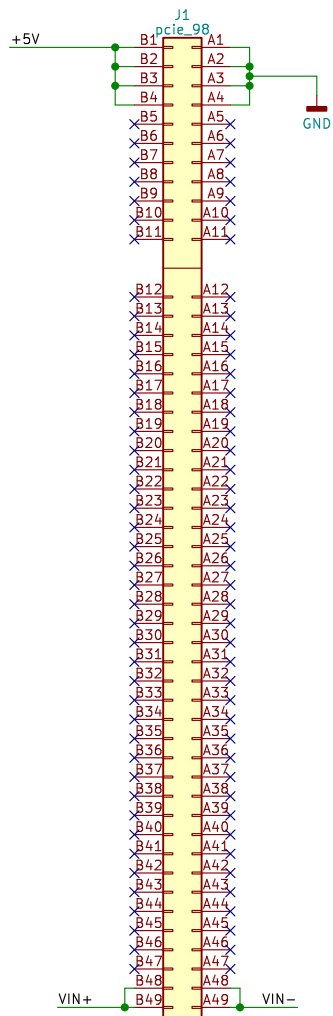
TODO: Rplace test connector with test pads.

TODO: Extend the pads of the fuses, and proection diods.

TODO: Increase the resistor of the greed +5V LED. It's too bright.
